ALAMEDA COUNTY
HEALTH CARE SERVICES

July 8, 2005

Subject: Petition Response to Fuel Leak Case RO0000516, Hooshi's Auto Service,
1499 MacArthur Boulevard. Oakland, CA 94602

Alameda County Environmental Health (ACEH) has prepared this letter in response to the "Petition for Closure" dated May 6, 2005, prepared by Cambria Environmental Technology, Inc. (Cambria). Cambria the environmental consultant for Ms. Naomi Gatzke, requests case closure for the above referenced facility. Based on their review of the site background and conditions, Cambria believes that this site meets the Regional Water Quality Control Board - San Francisco Bay Region's (RWQCBs) definition of a "low-risk fuel site" as defined in their memorandum "Interim Guidance on Required Cleanup at Low-Risk Fuel Sites", dated January 5, 1996. Cambria has attached their "Closure Request," dated July 21, 2004 and their letter titled "Clarifications Regarding Closure Request," dated October 6, 2004, as supporting documentation for their closure petition.

**Ground Water Elevation
 Contour Map**
 February 17, 1999

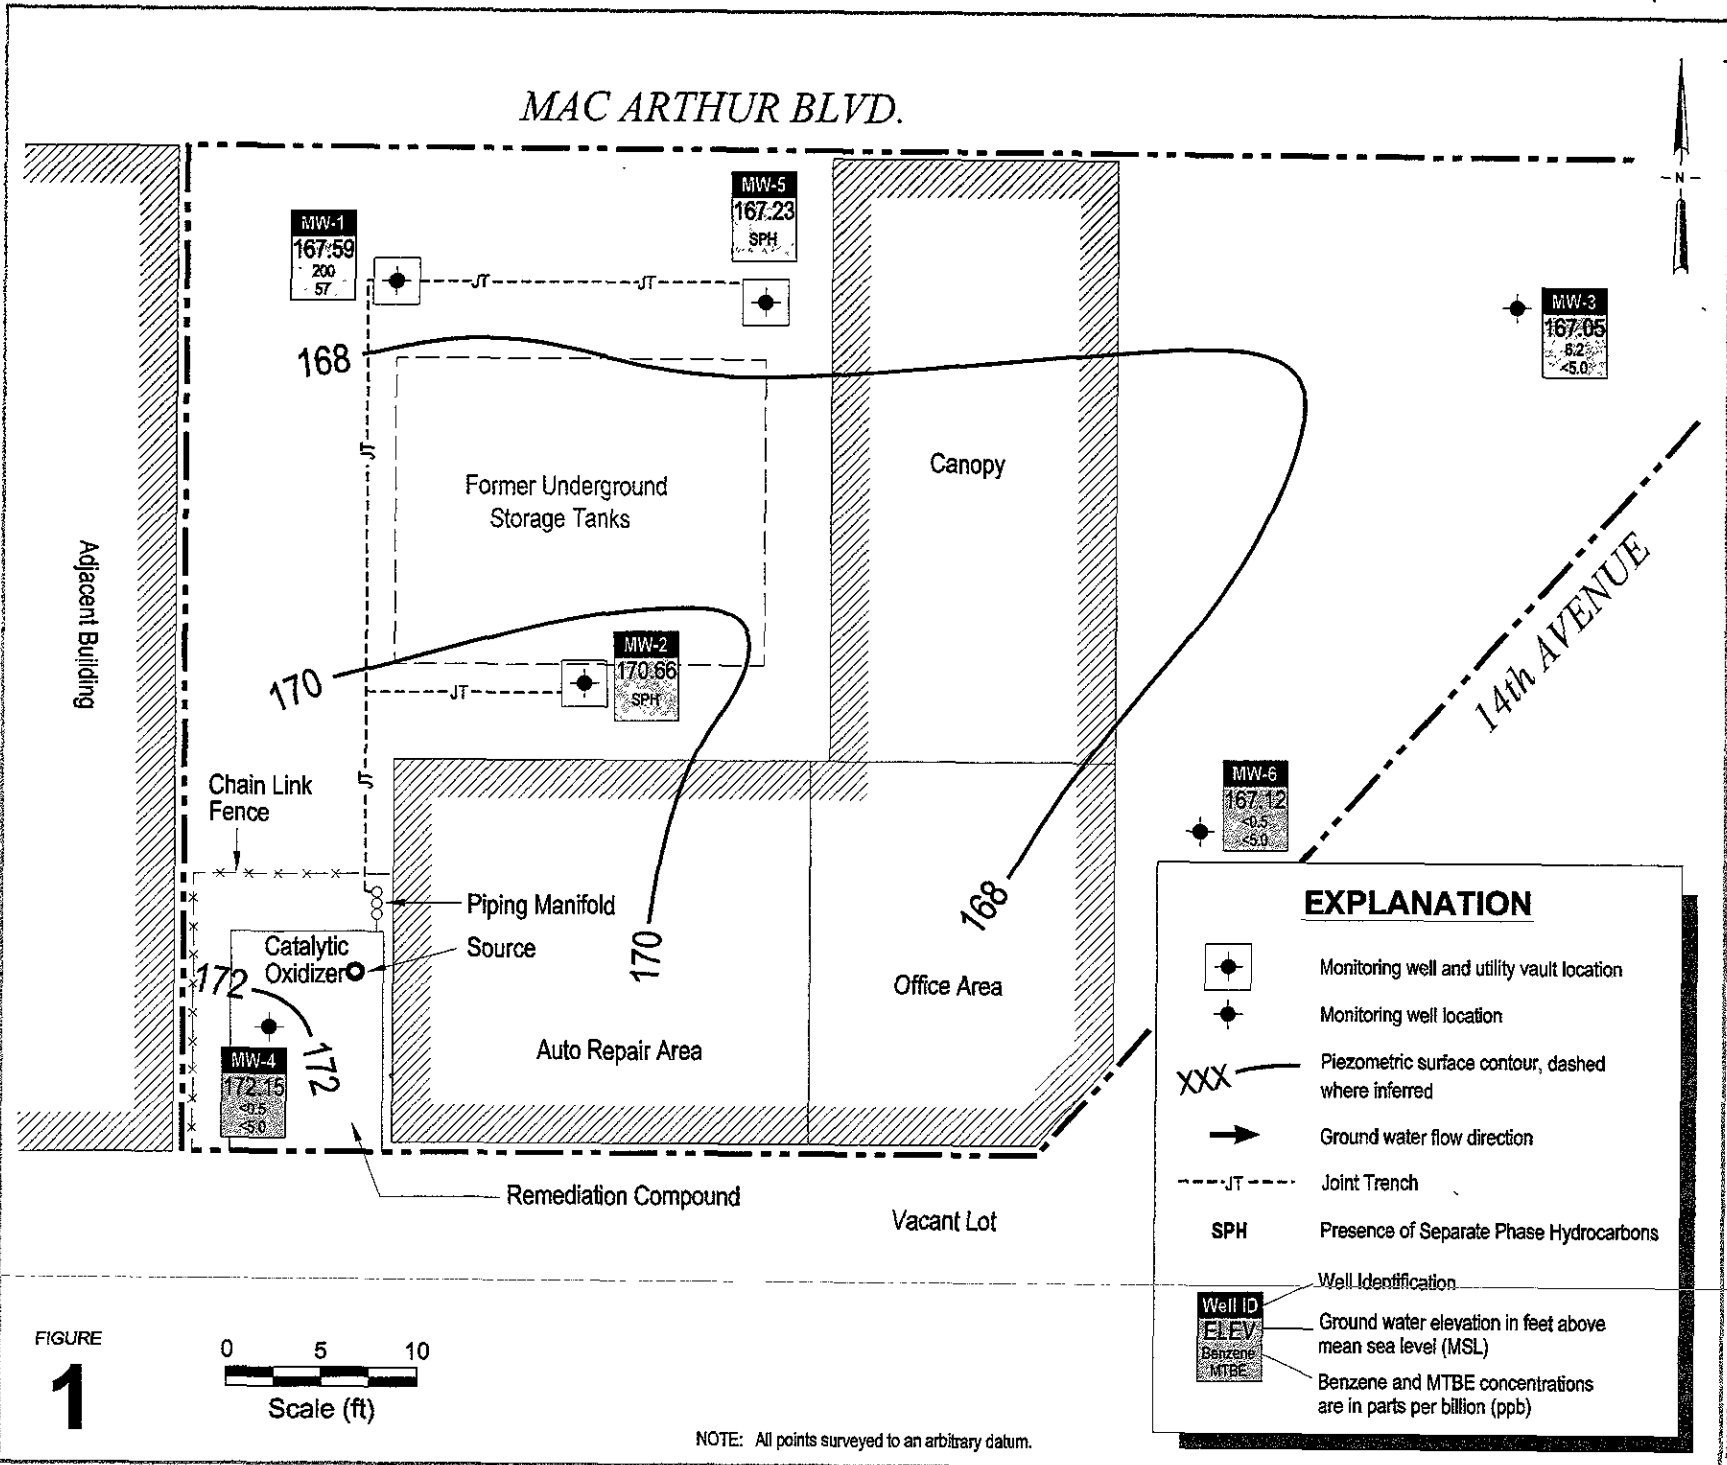
The site hydrogeologic conditions are also poorly defined. In particular, the groundwater flow field is not well characterized. The groundwater contour map included in the Closure Petition depicts equipotential lines drawn using water levels in site monitoring wells measured on April 2, 2004. The horizontal groundwater flow direction inferred from this figure is toward the southeast. Cambria states in their Petition that MW-4 monitors a dissolved plume downgradient from the source zone based on the flow directions inferred from the groundwater contour map. However, we have reviewed several other groundwater contour maps prepared using water level data on different dates (Exhibit 3) and horizontal groundwater flow directions implied by the equipotential lines in those maps suggest flow to the northeast. Some or most of the variability in the inferred horizontal groundwater flow direction could be attributed to hydraulic mounding in the center of the site. If there is mounding that is causing diverging flow, this

mounding can also cause downward vertical flow. This could be a mechanism whereby contaminants in or near the tank backfill could have been conveyed to depths greater than the total depth explored or monitored at the site. Cambria has not addressed this question, nor can they with the existing groundwater monitoring network since there are no well pairs or clusters installed at the site that could yield important information regarding the vertical distribution of dissolved contaminants or hydraulic head. There have been no hypotheses formulated to explain the mounding nor the causes of the (related?) erratic/variable apparent groundwater flow directions. That is a fundamental deficiency in the site characterization because an effective groundwater monitoring program cannot be developed until the site groundwater flow system is defined in three dimensions.
